**PETITION NO:** Z-86

**PROPOSED USE:** Retail

**PLANNING COMMENTS:**

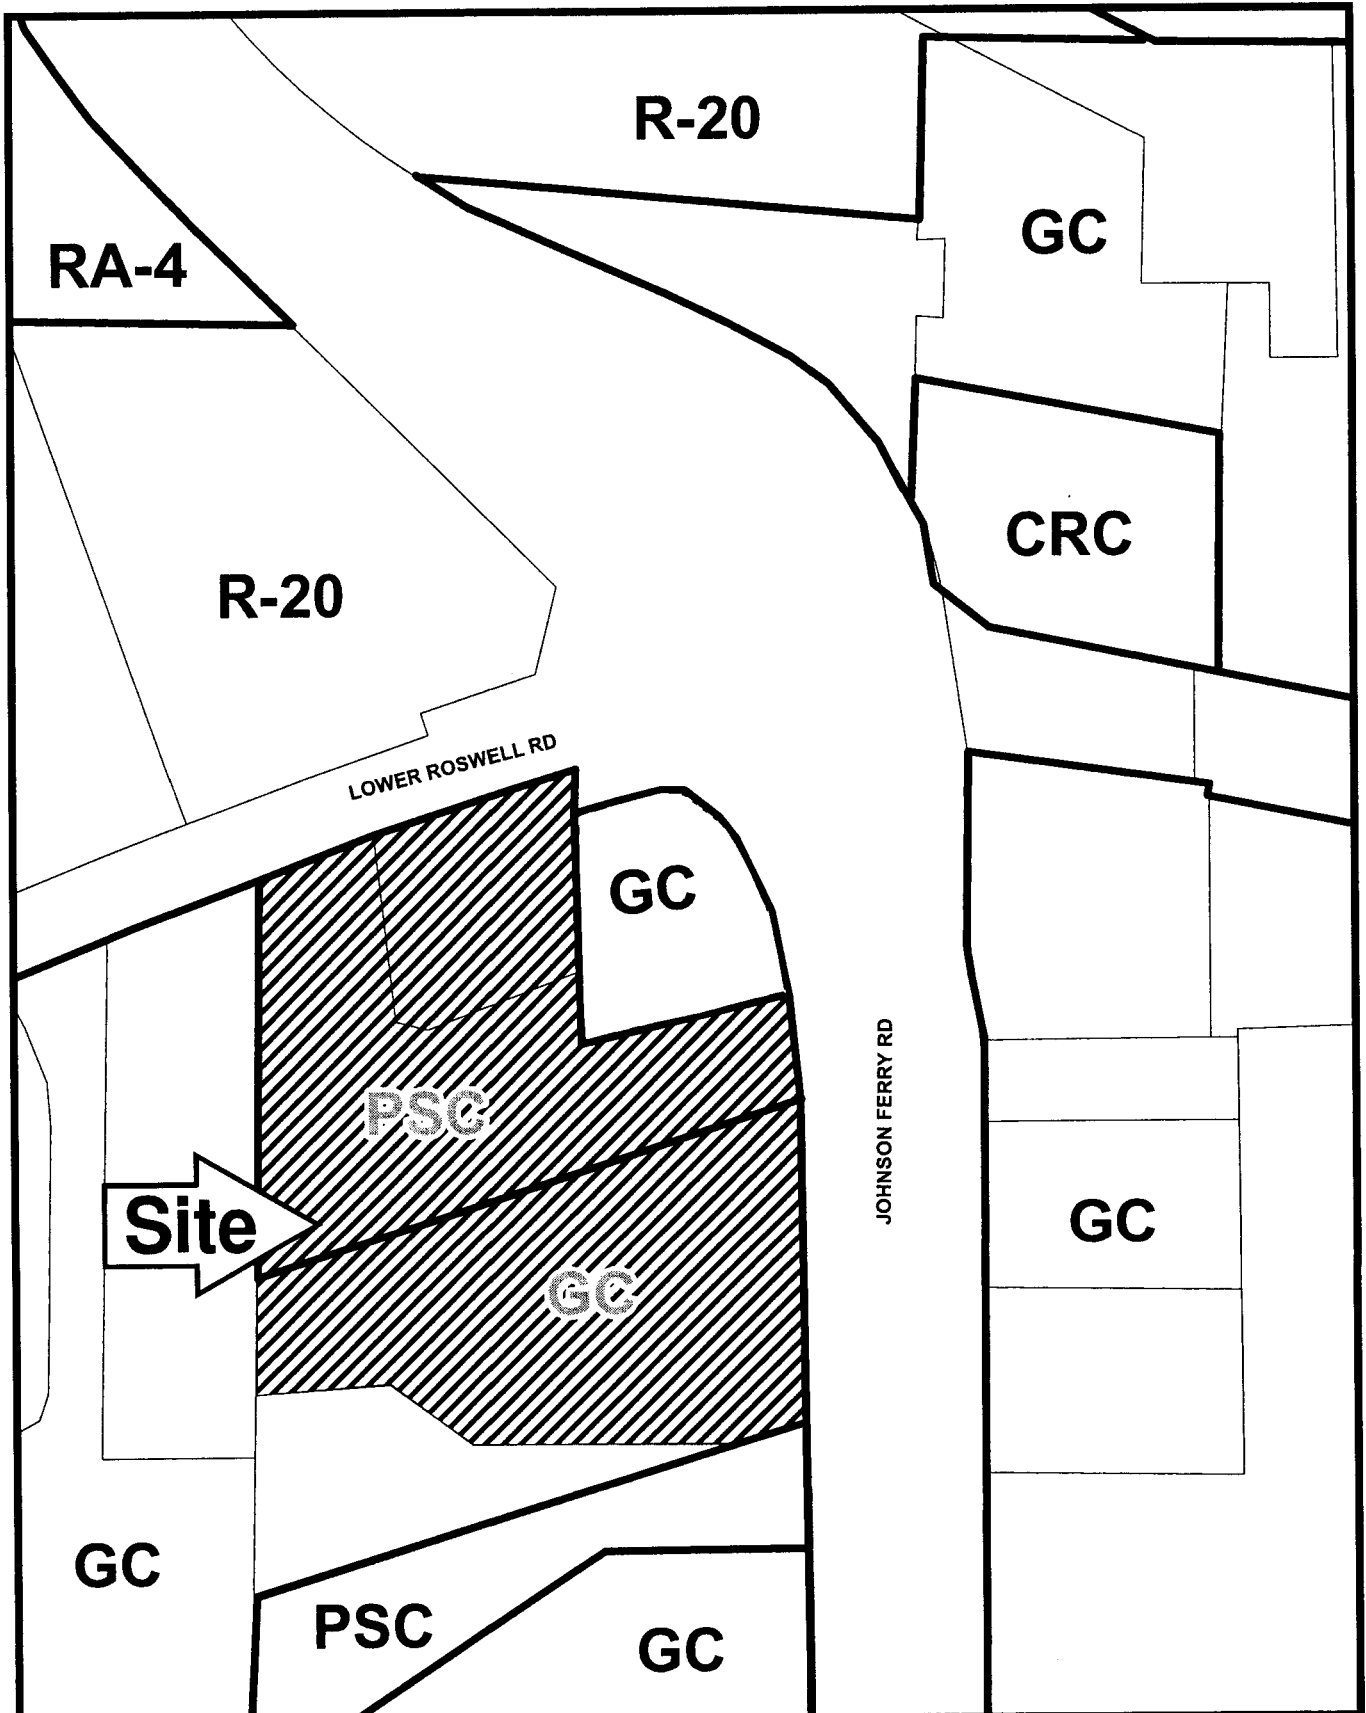
1. The proposed stormwater management facility must be tied directly in the existing downstream stormdrain system. The design engineer must verify the existing system capacity at Plan Review.
2. If segmented block or reinforced concrete walls are required for the detention pond, ramped access into the pond must be provided to allow for periodic maintenance activities.

Close all curb cuts along Johnson Ferry Road and construct one new curb cut aligning with the median break.

Coordinate with the adjacent property owner, Craig Automotive, to construct a shared driveway access along Lower Roswell Road.

Construct an access road/driveway along the western and southern perimeters of the development with inter-parcel access connections for all adjacent properties.

Extend the eastbound right turn lane along Lower Roswell Road.
